Encroachment Appeal - 135 Glen Road

Date: February 1, 2024

From: Director, Permits and Enforcement, Transportation Services

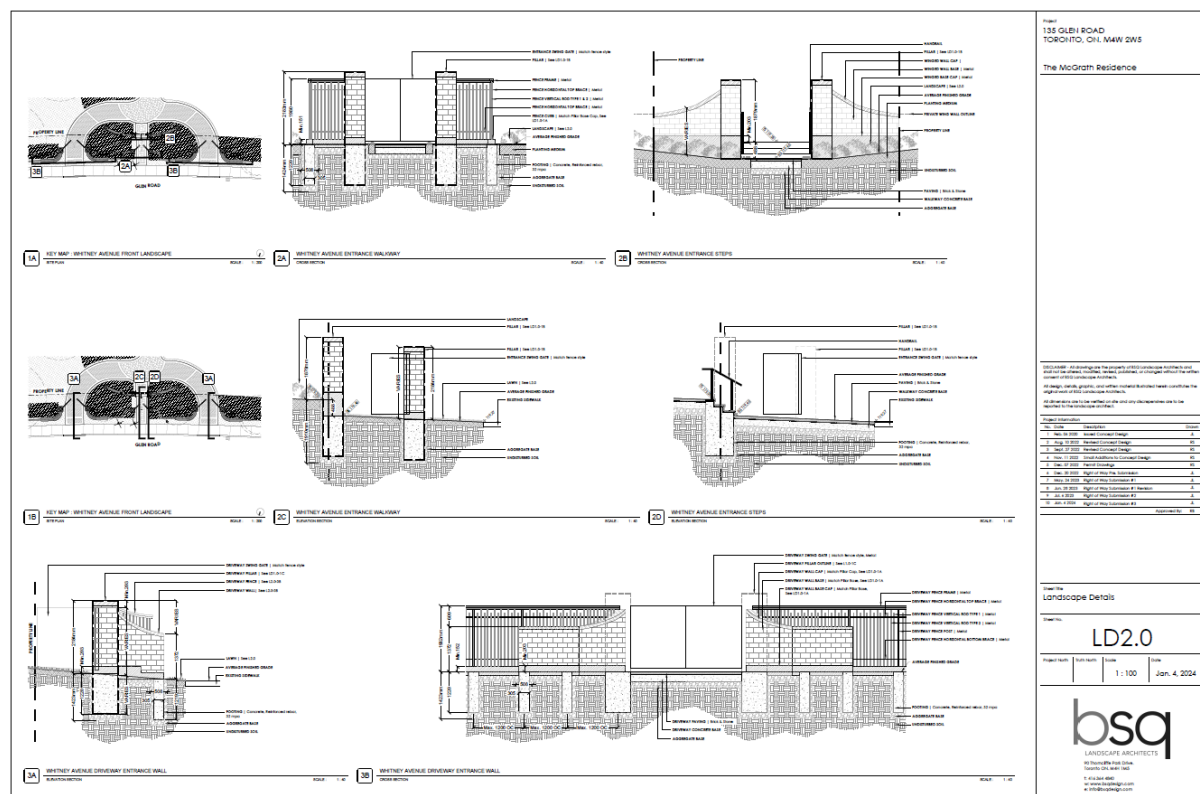
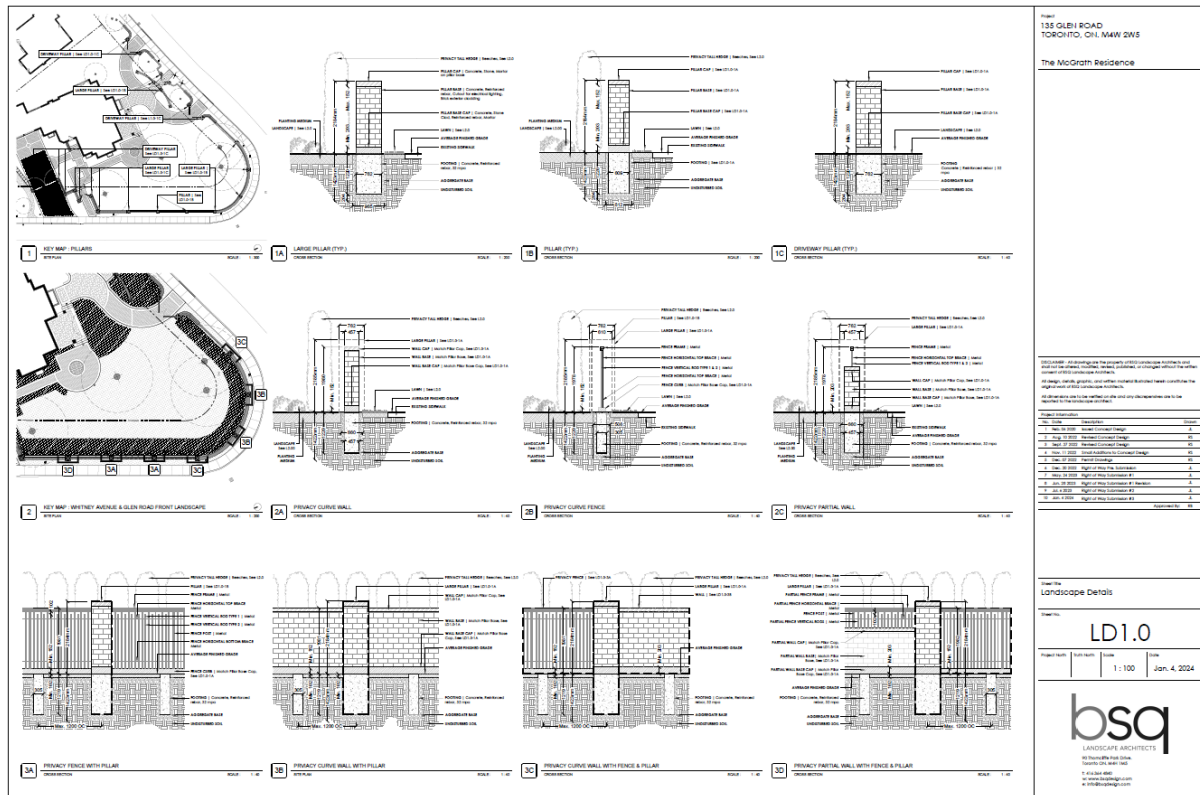
Transportation Services has reviewed the application and the property located at 135 Glen Road. The proposed encroachments have deficiencies that contravene Code Chapter 743. The deficiencies include the following:

- The proposed concrete and metal iron fence will be built to a height of 2.0 metres which contravenes Municipal Code Chapter 743 article 743-34A.(2)(a) "A fence located within a street can be built to a maximum height of 1.20 metres for that portion of the fence fronting the property, and 1.80 metres for any fence located in the flankage of the property, provided that to ensure unobstructed driver and pedestrian sight lines"

- The proposed stone/concrete/brick privacy walls and pillars will be built to a height of 2.2 metres which contravenes the Municipal Code Chapter 743 article 743-34A.(2)(a)[1] requirement that "No solid screen fence, privacy fence, railing, bollard, arbour, pergola, ornamental or retaining wall located within 70 metres of the intersection of any two or more streets shall exceed a height of one metre, with the height measured from the surface of the intersecting road"

- The proposed stone/concrete/brick privacy walls and pillars will be built to a height of 2.2 metres which contravenes the Municipal Code Chapter 743 article 743-34A.(2)(a)[2] requirement that " No solid screen fence, privacy fence, railing, bollard, arbour, pergola, ornamental or retaining wall located within three metres of a driveway that is adjacent a sidewalk, or the travelled surface of any road without curbs, shall exceed a height of one metre, measured from the grade of the adjoining driveway".

1. Toronto and East York Community Council not authorize the City to enter into an encroachment agreement with the owners of 135 Glen Road permitting the construction and maintenance of concrete and metal iron fences, and stone/concrete/brick privacy walls and pillars as it contravenes City of Toronto Municipal Code Chapter 743, Streets and Sidewalks, Use Of.
